# PUBLIC INTEREST REVIEW FOR GROUNDWATER APPLICATIONS

TO:		Wate	er Rights Se	ection				Date	e <u>D</u>	Decem	ber 22,	2015			
FROM	:	Grou	Indwater Se	ection_		Reviewer's Name									
SUBJE	CT:		ication G-			Reviewer's Name Supersedes review of Date of Review(s)									
OAR 69 welfare, to detern the press	<b>90-310-1</b> safety and nine when umption	<b>30 (1)</b> <i>nd hea</i> ether th criteria	<i>lth as descri</i> ne presumpti a. <b>This revie</b>	nent shall pi bed in ORS on is establi w is based	resume that 537.525. D ished. OAR <b>upon avail</b>	<i>a propose</i> epartment 690-310- <b>able infor</b>	ed groundw staff revie 140 allows <b>mation an</b>	water use will of w groundwate the proposed <b>d agency poli</b>	r application use be moo cies in pla	ons und dified o ce at t	der OAI or condi <b>he time</b>	R 690-31 tioned to of evalu	0-140 meet

A. <u>GE</u> A			$\frac{\mathbf{ORMATIC}}{\mathbf{ORMATIC}}$					and Lori L Willamet		Co	ounty:	LINN	Basin,		
A1.		Santia						vv maniet					_ Dasin,		
A2.	Propose	d use	Irrigation	n (211 ac P	Primary)	Seas	onality: <u>l</u>	<u> March 1 – O</u>	ctober 3	1 (244	<b>d</b> )				
A3.	Well an	d aqui	fer data ( <b>atta</b>	ach and nui	mber logs

### **Stream-depletion Model Results**

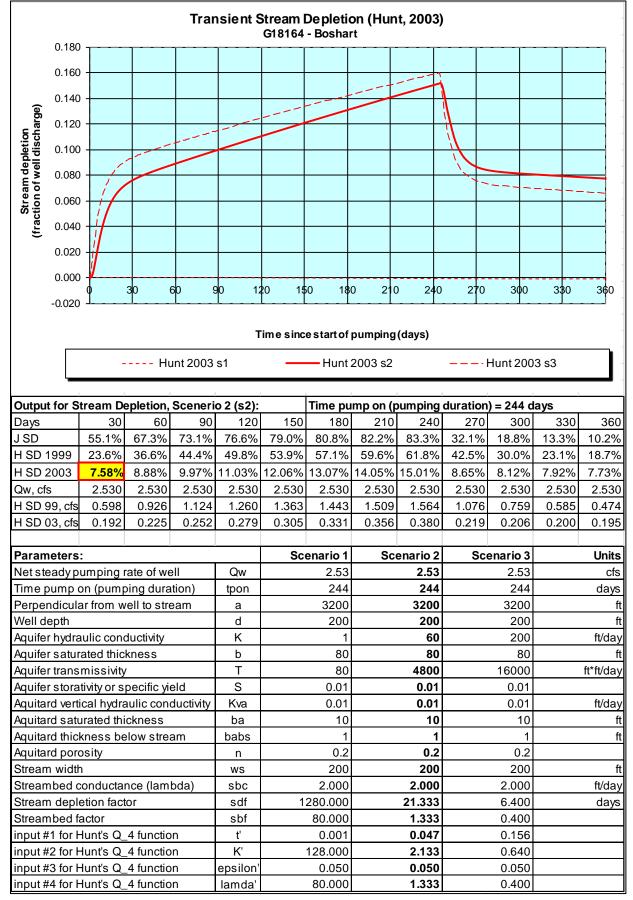
**Comments:** Interference @ 30 d was estimated using the Hunt (2003) analytical model and parameter values taken from Herrera et al., (2014). Model output for the Well #2 (nearest well) is shown below – results for Well #1 are similar.
